**CONTRACT NO. T-668A, CAPITAL PROJECT 0301A  
SCUDDER FALLS BRIDGE REPLACEMENT PROJECT**

**RESPONSES TO CONTRACTOR INQUIRIES SUBMITTED TO THE COMMISSION  
FROM NOVEMBER 2, 2016 THROUGH NOVEMBER 8, 2016  
INQUIRIES BY POTENTIAL BIDDERS**

On Sheet 51 of 62 in Package A – Part 5, the SECTION A-A is revised as follows.

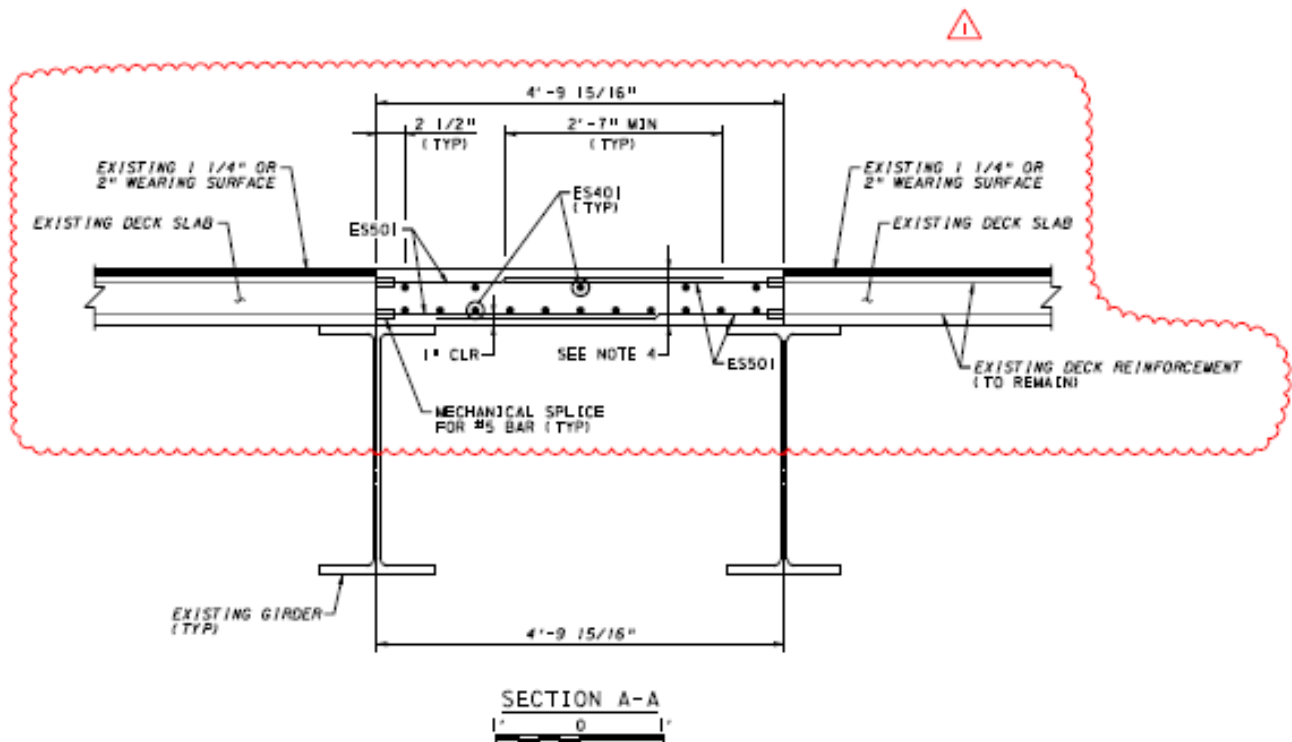
**Inquiry 176:** Refer to S-36221 Sheets 8 & 51 and S-36222 Sheets 7 & 48. The typical existing sections show an overlay for the riding surface on the bridge decks. The details for the temporary median decks show matching the existing deck thickness. However, the temporary decks actually need to be thicker to match the grade of the adjacent overlay. Please advise how this grade differential is to be handled.

**\*Response 176: S-36221:** On Sheet 51 of 62 in Package A – Part 5, SECTION A-A will be revised to show the existing wearing surface. The proposed top of temporary deck will be shown at an elevation equal to the top of wearing surface. The 9 1/2" MAX temporary deck thickness presently shown in SECTION A-A accounts for the thickness of the wearing surface. Refer to Notes 2 and 4 on Sheet 51 of 62. Note that the revisions to the temporary deck slab reinforcement will be made to allow for adequate reinforcement bar development.

On Sheet 48 of 62 in Package A – Part 5, the SECTION A-A and B-B is revised as follows.

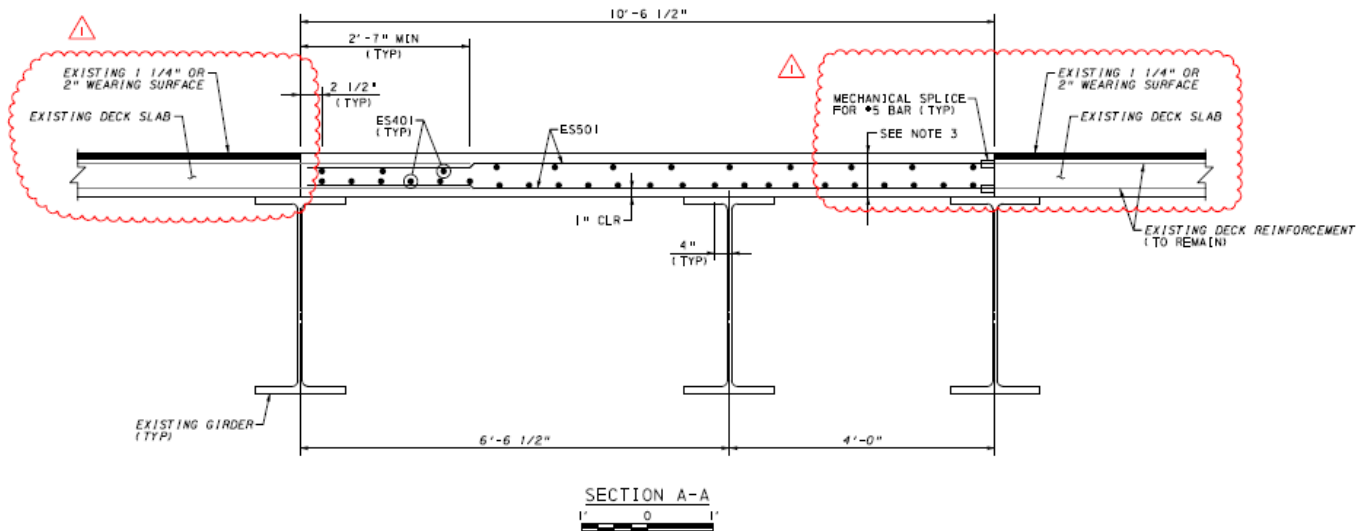
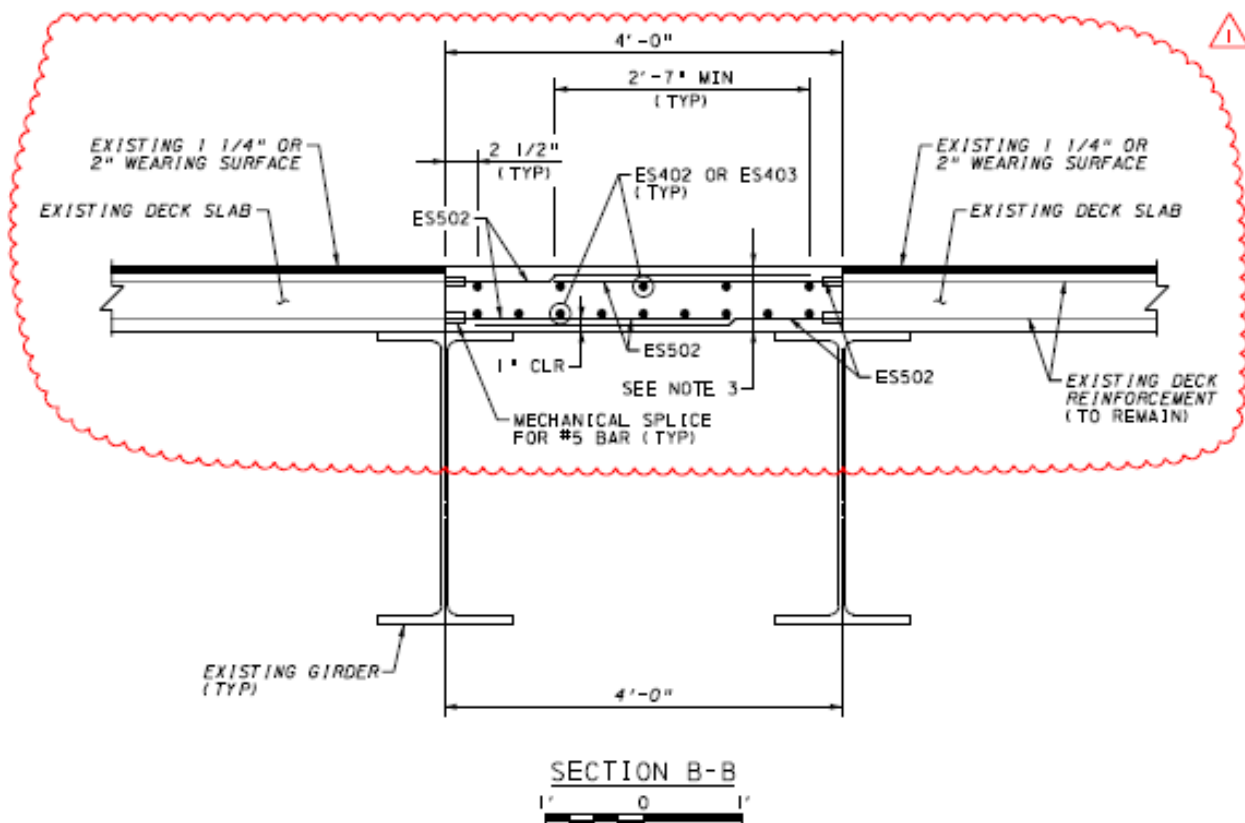
**Inquiry 186:** Addendum No. 4 revised S-36222 Plan Sheet 48 of 62 to add mechanical couplers to transverse median bars due to insufficient lap length available from projecting bars. Won't the same be true of the bars in S-36219 temporary median deck?

S-36222: On Sheet 48 of 62 in Package A – Part 5, SECTION A-A AND B-B will be revised to show the existing wearing surface. The proposed top of temporary deck will be shown at an elevation equal to the top of wearing surface.
